Determination 2011/096

The refusal to grant an amendment to a building consent for proposed remedial work, and the issuing of a notice to fix for a 13-year-old house with monolithic cladding at 54 John Rymer Place, Kohimarama, Auckland

Figure 2: The work in the proposed amendment

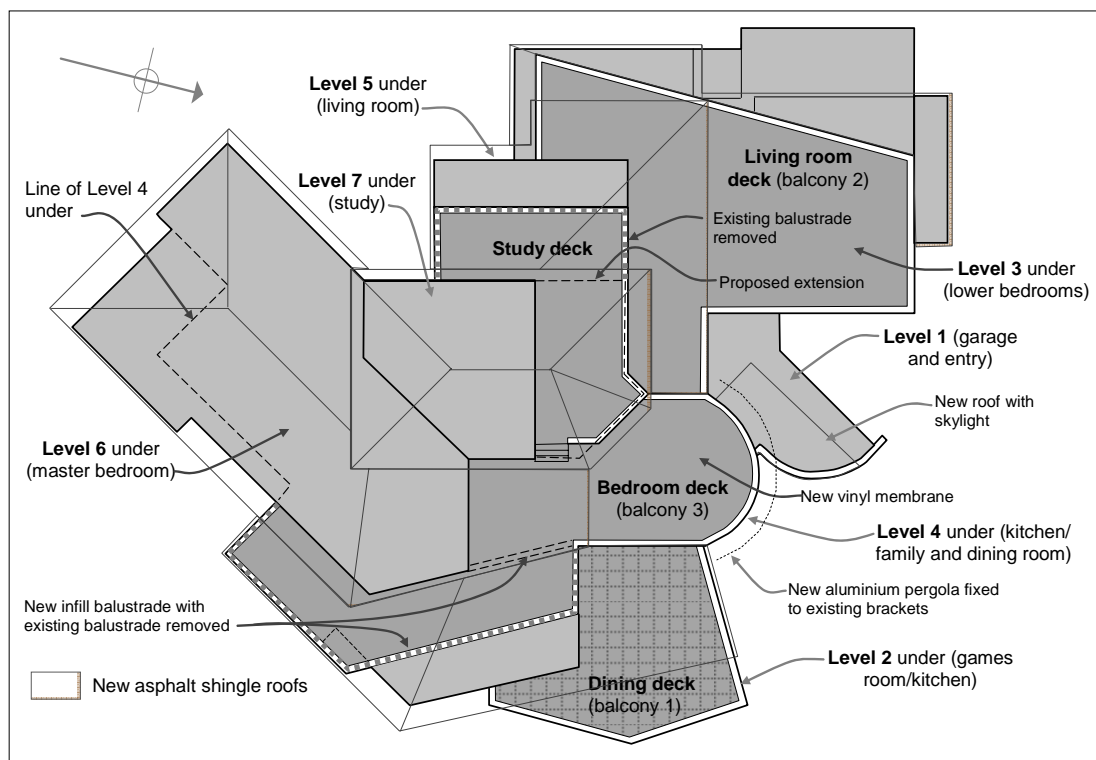
- Many new roofs form lean-tos against existing plastered walls, with the specification describing cuts and repairs to existing plaster that will risk
 - cracks at joints between new and existing plaster

- damage to the original building wrap and plaster above the cut, due to new blocking and fixings needed for fixing existing backing sheets.
- Some roofs also form lean-tos against existing balustrades, but

- balustrade framing is likely to be decayed below capping cracks and investigation is needed to assess extent and replacement
 - rafter fixings are not shown

- the aluminium flashing at the balustrade junction is not shown.
- For the asphalt shingle roofing, there are
 - references to metal flashings and folded shingle flashings, which are not supported by manufacturer's instructions or the BRANZ Appraisal

- metal horizontal apron flashings intersect with standard, with no details at junctions.

- New infill cladding with timber framing lacks details to appropriately cover
 - horizontal junctions at new framing under the ends of lean-tos
 - the new framed walls above the existing study deck balustrade
 - the thickness difference between new cladding and the existing plaster
 - the new and re-used windows in the study extension
 - the balustrade infill framing.
- There are no details of capping to the master bedroom deck infill balustrade.

- Some roofs are to be fixed to existing roof or balustrade framing, but there is no process for the investigation that will be required to determine the
 - locations of underlying original framing members
 - adequacy of the original framing at high risk areas and balustrades
 - adequacy of proposed fixings.
- There is information lacking in a number of other areas, including
 - revised calculations for new loads from the study extension
 - information on aluminium posts supporting roof extensions
 - post fixing details
 - revised bracing calculations and information on the new roof trusses.

- Information is not presented in a logical and clear form to allow the authority, builder and other trades to work easily with the information given in the drawings and/or the specification.

- The plans are not drawn to appropriate scales with sections clearly labelled and cross-referenced to plans, elevations and expanded details.
- Colour is used to describe various elements, which can be affected by copying, making different colours difficult to distinguish. (This was evident at the hearing as elements that were orange on an original drawing appeared to be reproduced as red.)

- Line conventions are inconsistent and unclear, making it difficult to clearly distinguish between new and existing work.
- There are insufficient expanded details and dimensions to demonstrate junctions, flashings, overlaps, fixings etc.

- The accuracy of details is questionable.
- There are many critical junctions that are not detailed.
- The plans used in the original consent remain current and should be amended to reflect the proposed remedial work.

8.2.3 The expert concluded that plans were not of a ‘standard suitable for issue for building consent or construction’ and did not ‘provide reasonable grounds to conclude that remedial work carried out in accordance with the amendments proposed would comply’ with the Building Code.

7.4.1 I accept that the proposed amendment may be completed as the first stage in response to the notice to fix. However, I am not satisfied that the work as detailed in the proposed amendment will meet the provisions of Building Code.

7.4.2 I consider that further investigation is necessary to confirm the condition of the building elements that the new work is to be fixed to; however, the amendment may make reference to this being undertaken as part of the proposed work. If that is the case, the proposed amendment shall detail the steps to be taken should defective or damaged timber and the like be encountered.
